**Overview:** Mis-Wired door lock connector, field repair required.

**Issue:** A review of the latest samples of **FTI-TLP4 T-harnesses** has revealed a misplaced trunk output wire in the 6-pin Lock Accessory Connector requiring that the wire be relocated to the correct position, to ensure safe operation when used. **Using the harness without addressing the issue will result in failed trunk/hatch control, and possible damage to the vehicle BCM.**

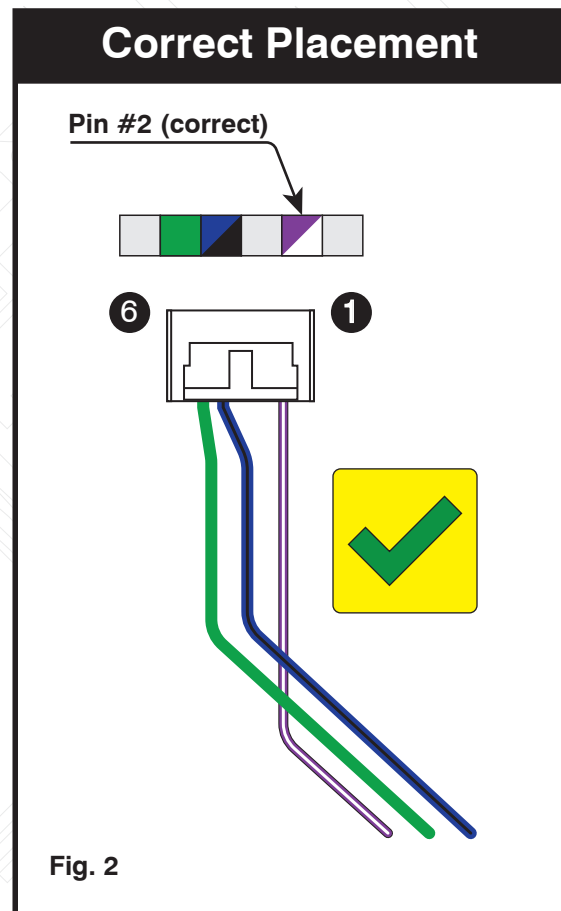
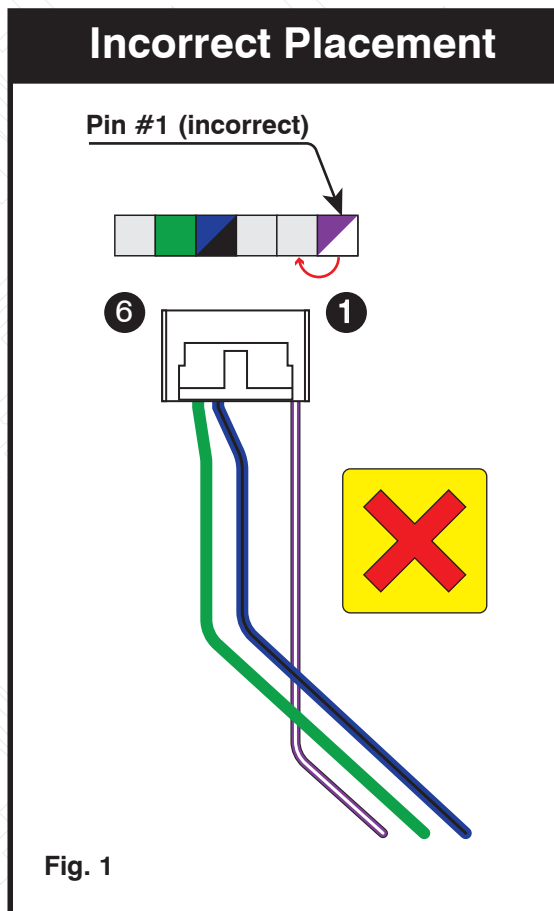
**Correction:** The harness purple/white wire in the latest production run of FTI-TLP4 harnesses has been inserted in the position normally used for the +12V power connection in the accessory harness. Before completing the installation, the installer must relocate the harness purple/white wire to the correct position, 1 space inward on the 6-pin connector, see illustrations below in Fig. 2.

To relocate the terminal, using a fine pick or Olfa type knife, depress the terminal locking barb and pull the purple/white wire from the connector housing. Once the terminal has been removed from the housing, again using the pick or knife, lift the locking barb about 1/16" (1.5 mm) and reinsert the terminal in the correct position. If upon initial examination of the harness the lock accessory connector looks like the illustration in Fig. 2, no modification is necessary, the wire is in the proper position.
